Re: Subdivision Application
40 High Street, Armonk, New York

RE: 40 High Street Subdivision
40 High Street
Tax ID – Section 101.03, Block 3, Lot 83

I am pleased to resubmit updated plans in support of the Subdivision application for the 40 High Street Subdivision property located at 40 High Street, Armonk NY, Section/Block/Lot: 101.03/3/83 in the Town of North Castle, Westchester County. Plans and comments have been addressed as follows to address conditions outlined in Resolution of Approval:

TITLE: **INTEGRATED PLOT PLAN**

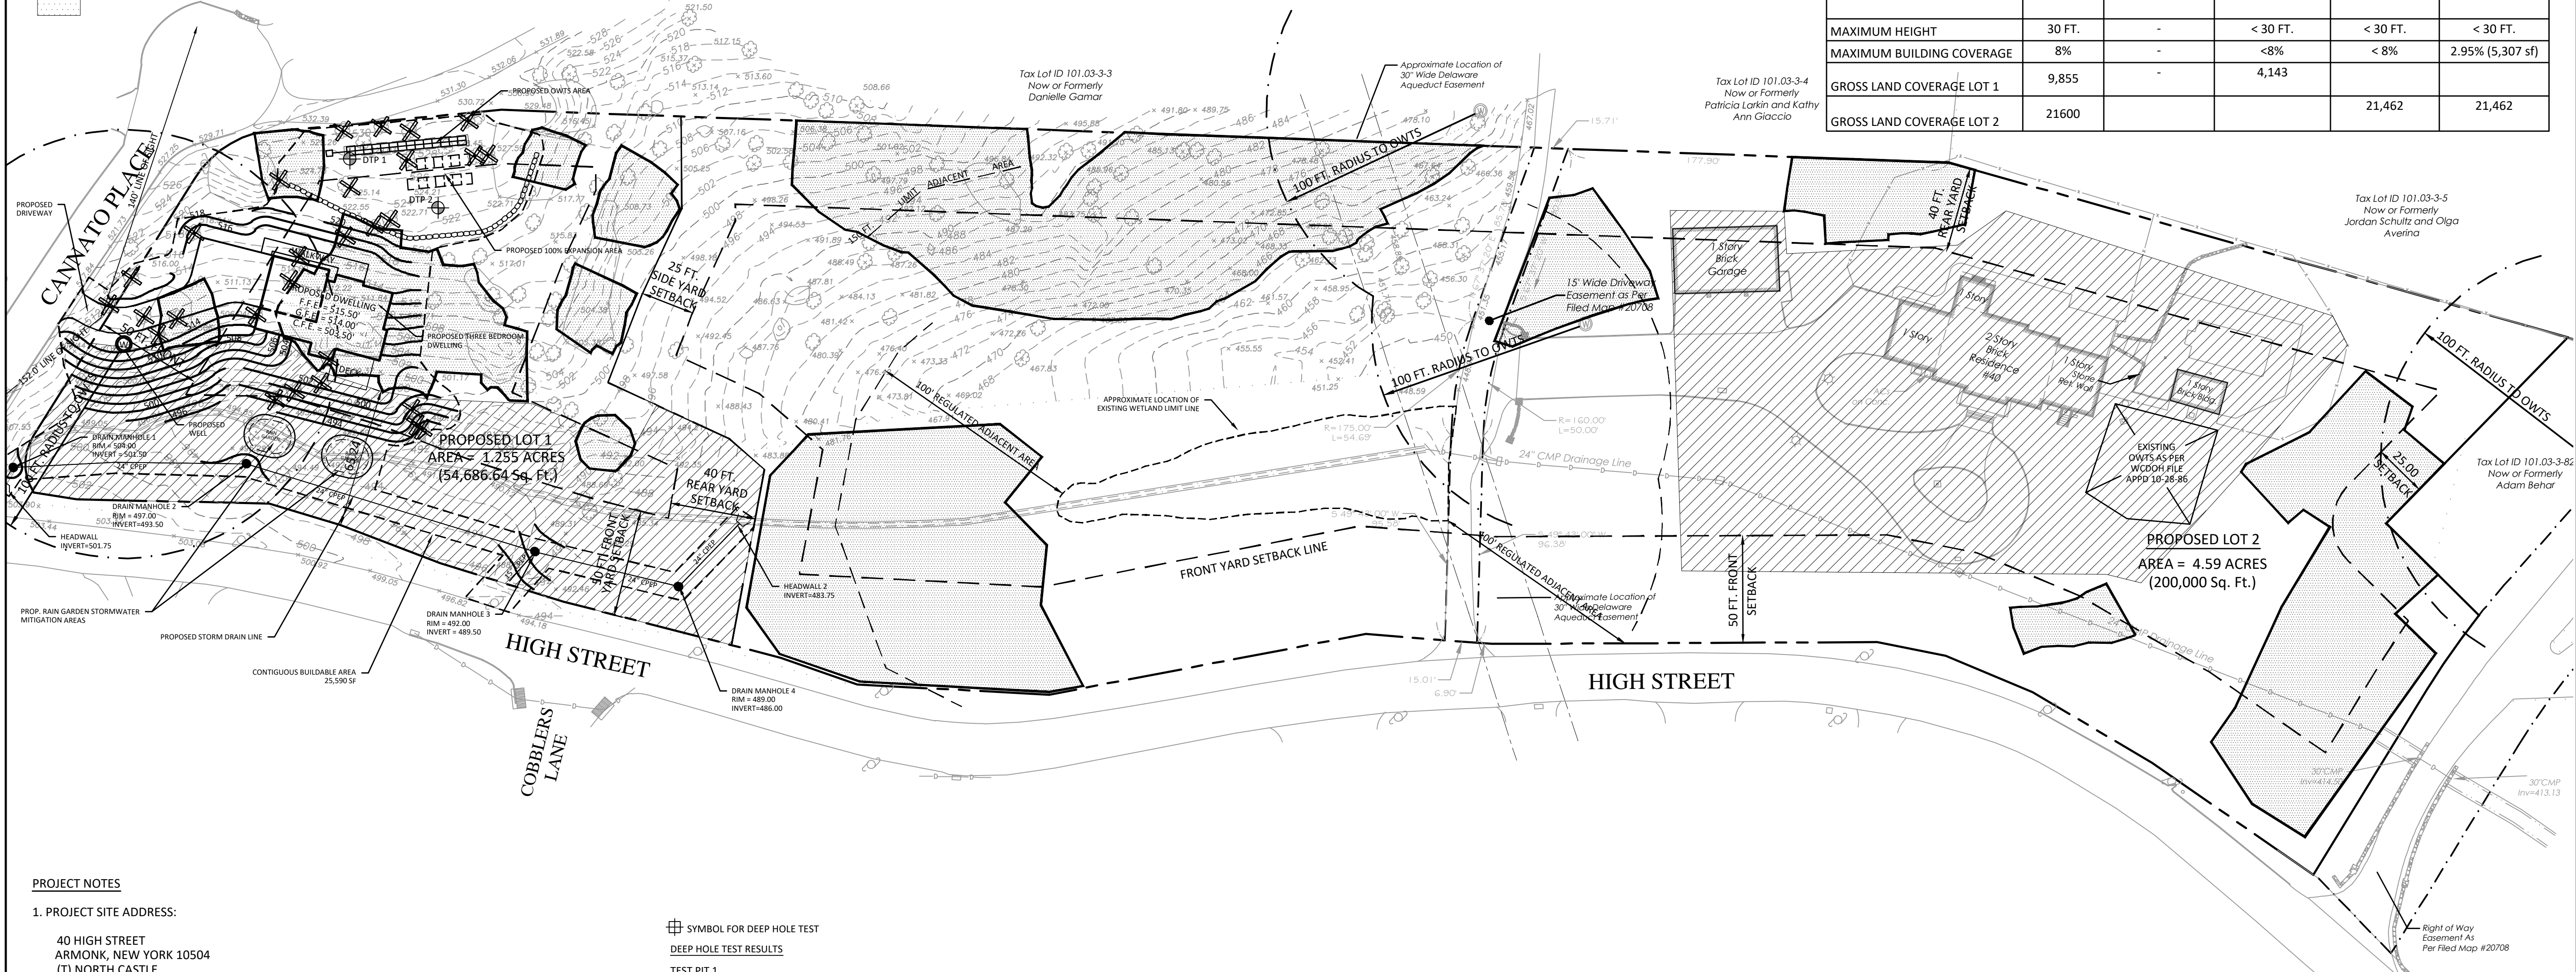
3. *The applicant has calculated net building lot area for the two (2) proposed lots which will be created by the proposed subdivision. The area of steep slopes on Lot #2 seem to have only considered slopes within the northern portion of the lot where topography is provided. The Applicant shall include steep slopes across the remainder of the property to the satisfaction of the Planning Department and Town Engineer.*

19. *The Applicant shall submit an exhibit demonstrating that proposed Lot 2 contains a 25,000 square foot contiguous buildable area.*

20. *The subdivision plat shall include a note, to the satisfaction of the Planning Department, indicating that the future subdivision of Lot 2 shall be prohibited.*

Response: Net building lot area for Lot #2 does consider the total area of slopes which exist on Lot #2. The Westchester County GIS topographical mapping was utilized in determining designated steep slope areas on the southern portion of the property. Areas designated as regulated steep slopes were transferred onto the Integrated Plot Plan and used in the net building area calculation provided on the plan.

Response: The required Contiguous Buildable Area for new lots created in the R-1A Residence Zoning District with On-Lot Sewage Disposal and Well is 25,000 square feet. The IPP has been updated to reflect the Contiguous Buildable Area as defined in Section 355-26 of the North Castle Town Code. The Contiguous Buildable Area for proposed Lot 1 is 25,590 square feet. The minimum width of the area is approximately 64 feet. The dimension has been provided on the plan in the narrowest section of the area. The Contiguous Buildable Area for proposed Lot 2 is 42,380 square feet and has been indicated on the Integrated Plot Plan.

Response: The Integrated Plot Plan has been updated to include a note prohibiting the future subdivision of Lot 2. The Plat will include a similar note.
